Noncompliant Weld Inspection Techniques

Line 114 Non Destructive Examination Final Report

Issue Date December 5, 2013

Weld 771 cited for indications of internal undercut from 12-24

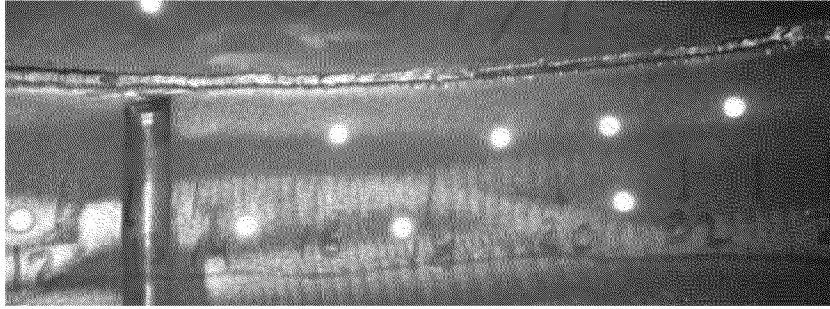
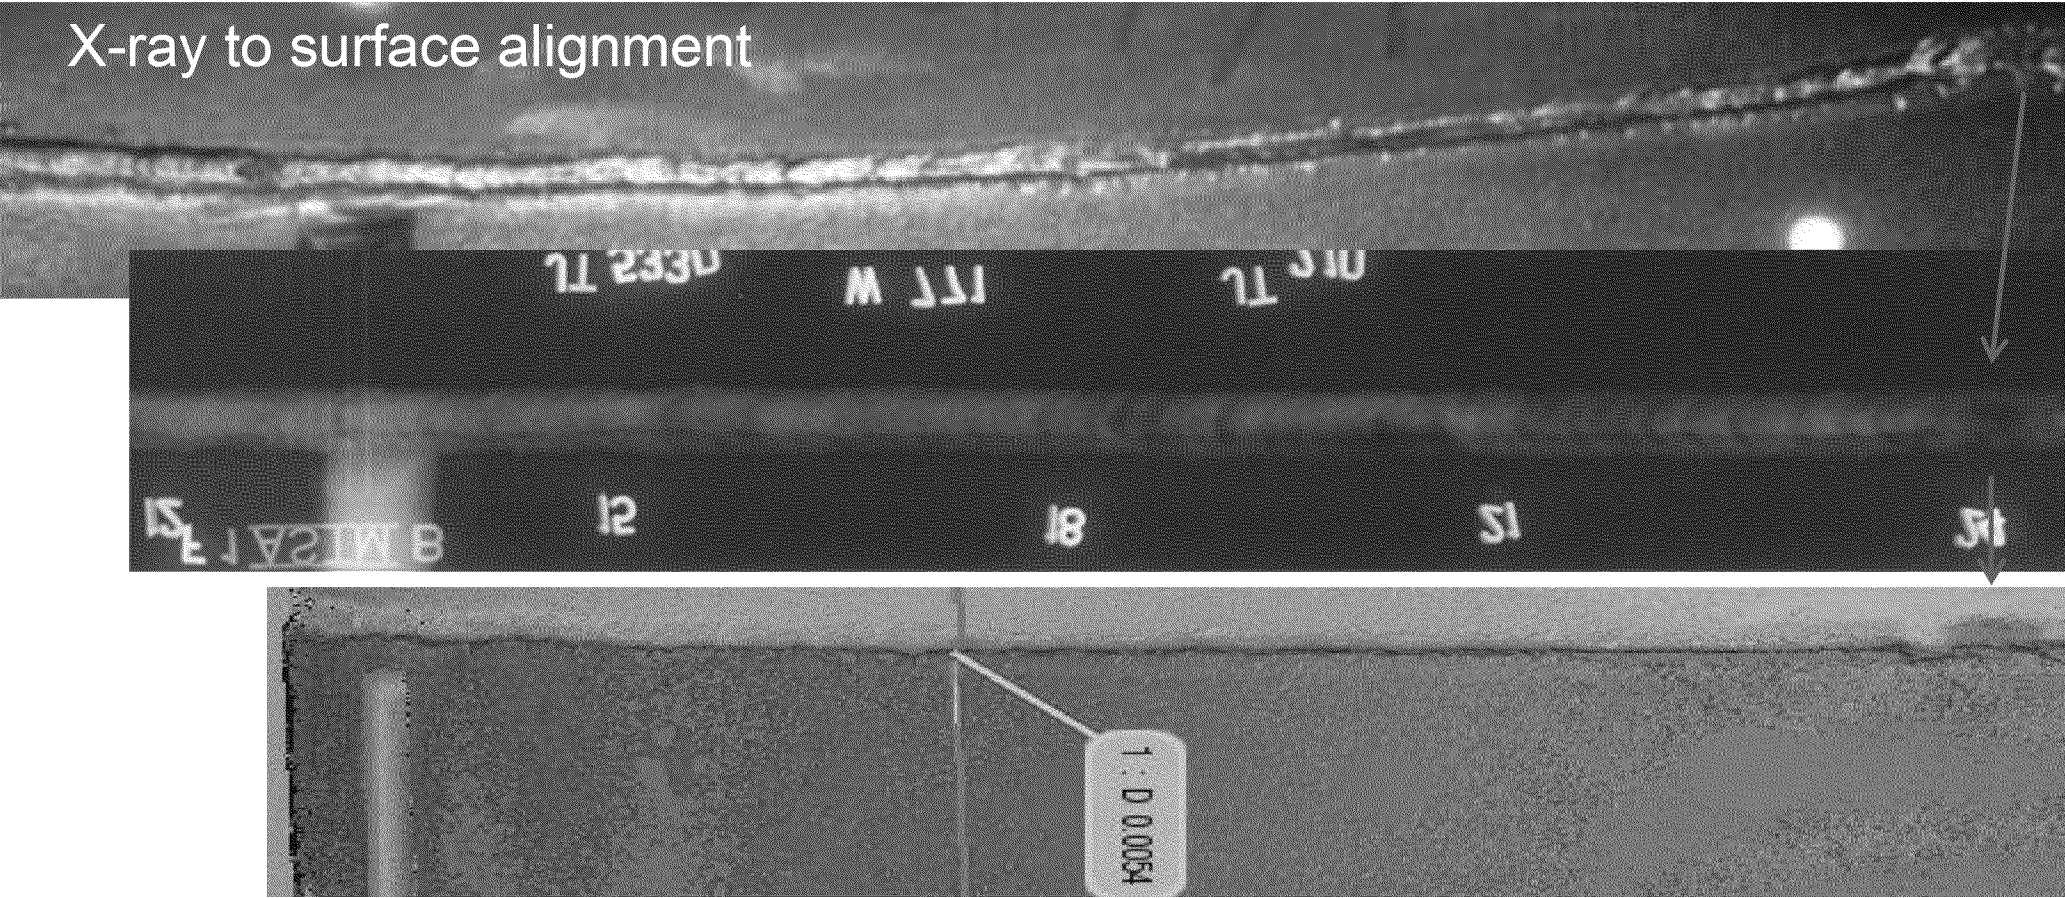
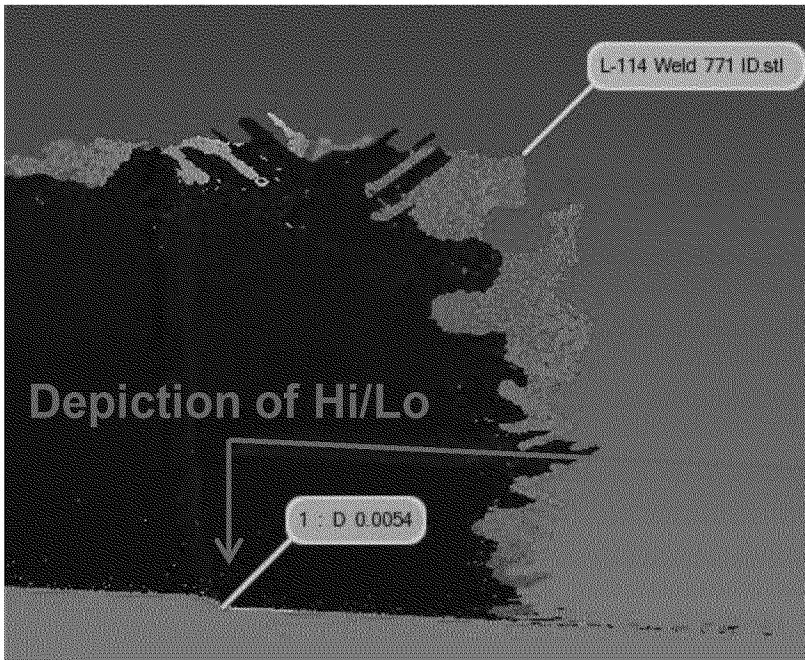
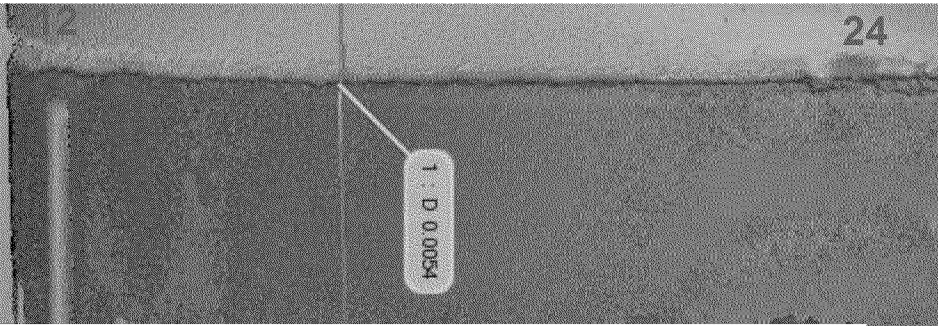
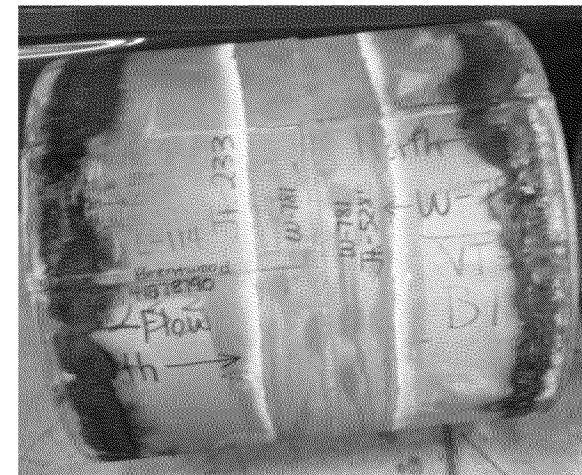
RT estimated depths of up to 0.008 inches

- Confirms indications are mostly diffraction effects on minor hi/lo condition with 0 UC
- Deepest region along length is 0.006 inches
- Weld is acceptable per API 1104

- * Confirms UC indication is diffraction/"shadowing" from high/low condition
- * Weld is acceptable per API 1104

Weld 781 cited for indications of internal undercut from 44-49

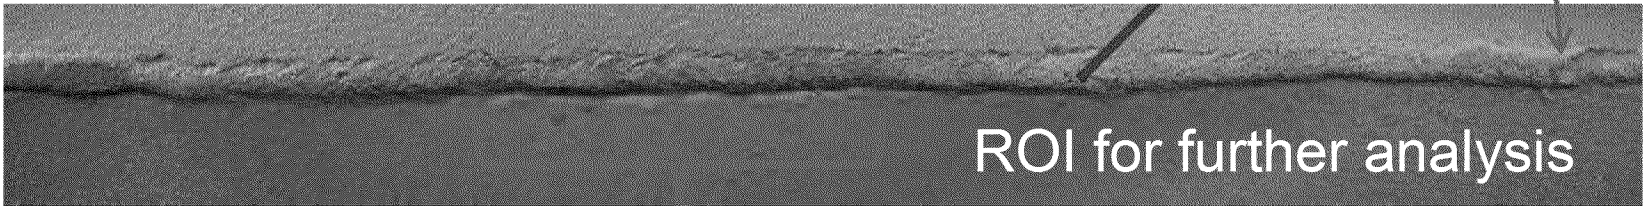
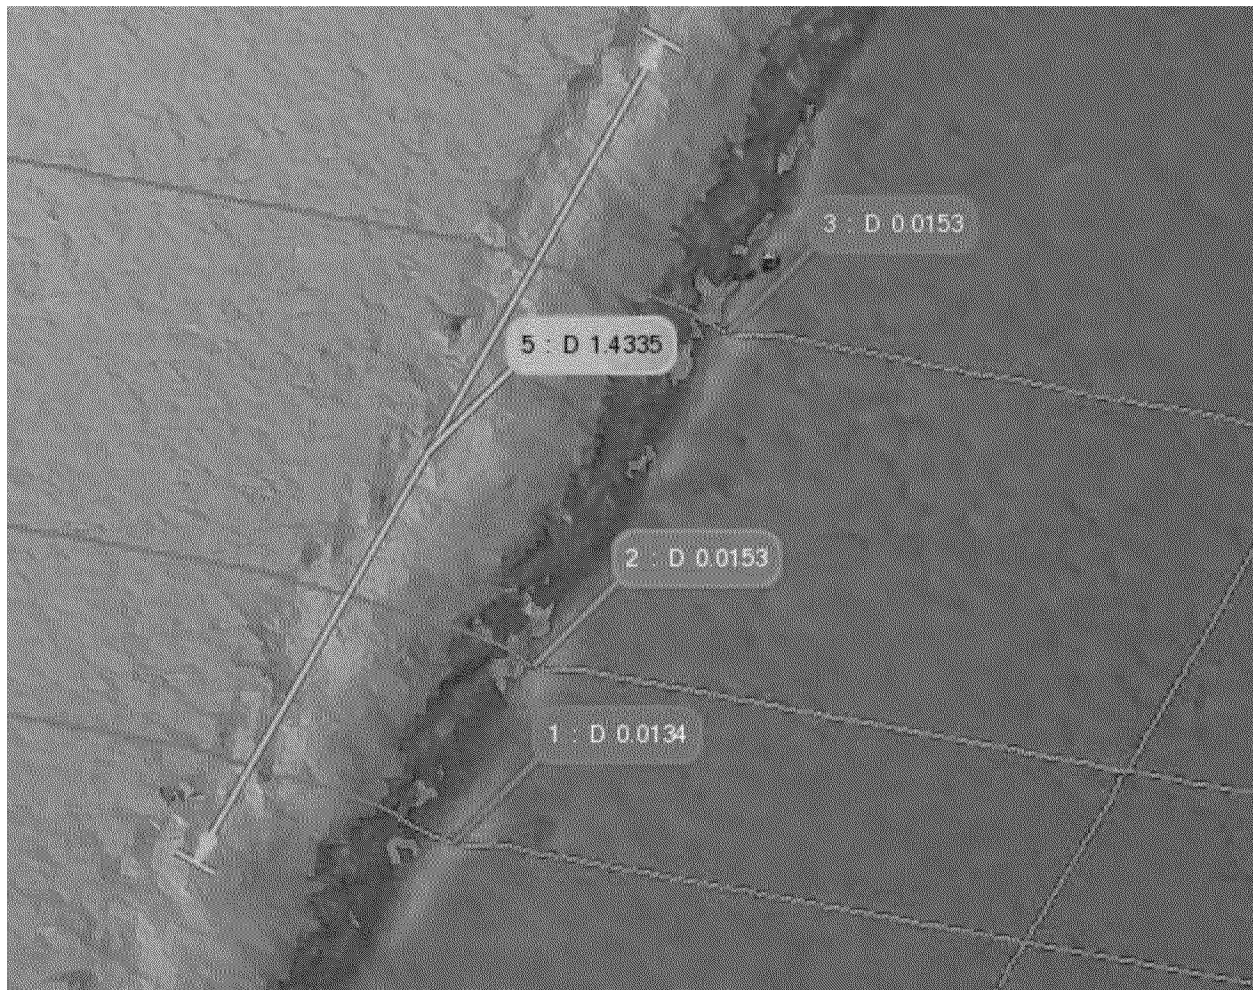
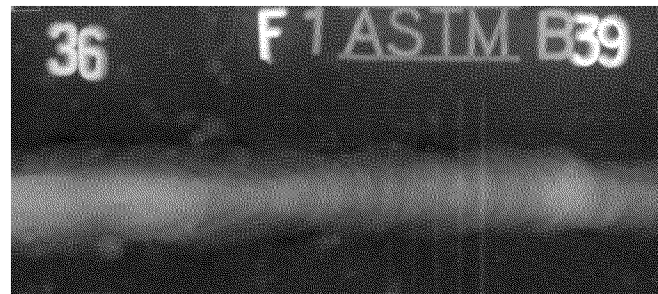
Confirms indications are mostly diffraction effects on minor hi/lo condition with 0 UC

- * Confirms UC indication is, in the majority, diffraction/"shadowing" from high/low condition with less than 2 inches of up to 0.015 inches deep IUC
- * Weld is acceptable per API 1104

Weld 738 cited for indications of external undercut from 36-42

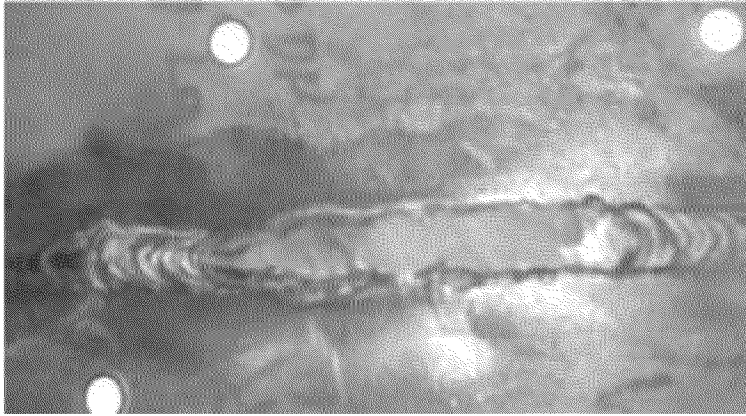
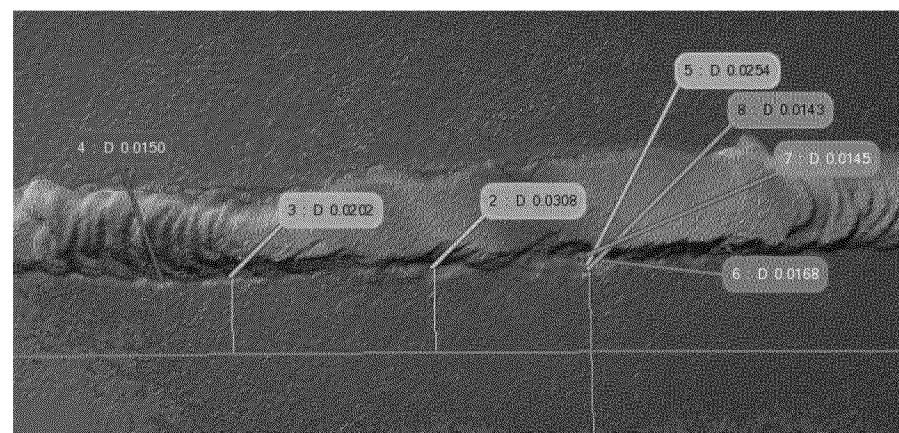
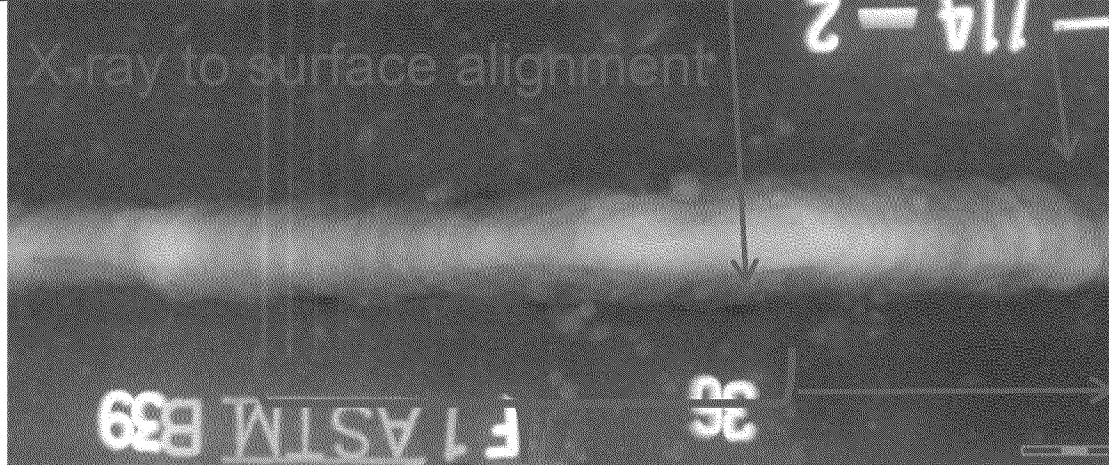
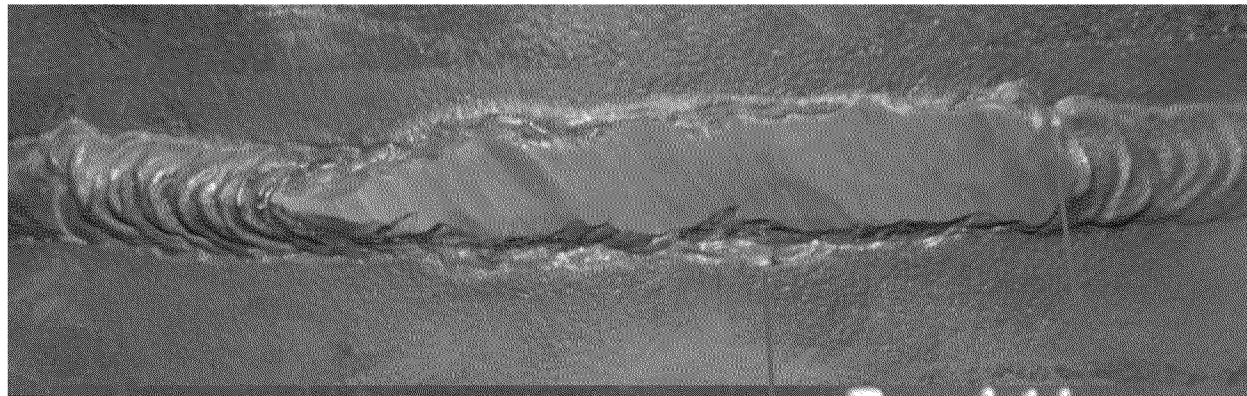
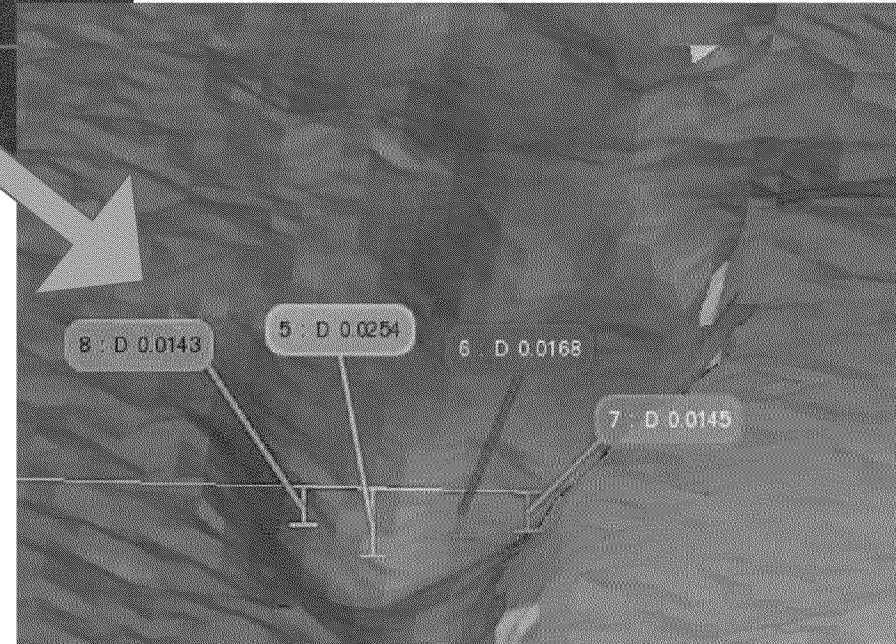
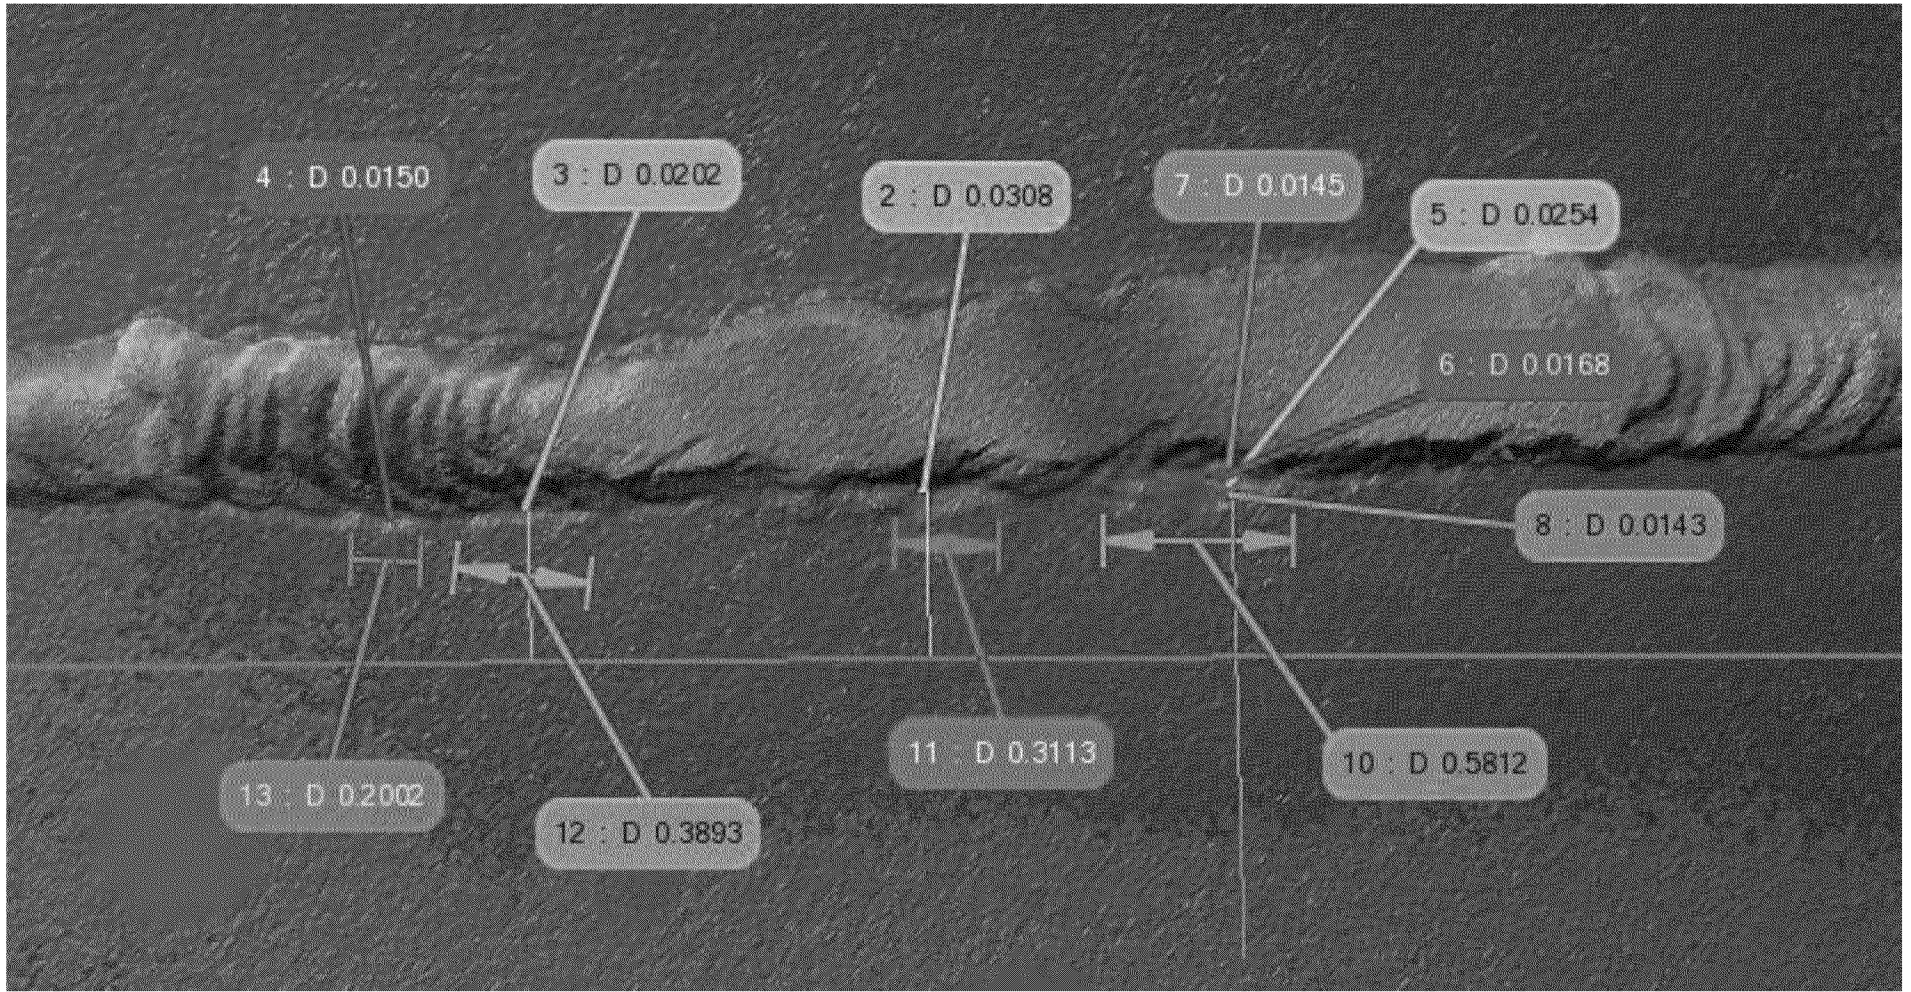
RT estimated depths of up to 0.030 inches

External undercut identified up to 0.030" deep

Sum of UC lengths < 1.5"

Weld is acceptable per API 1104
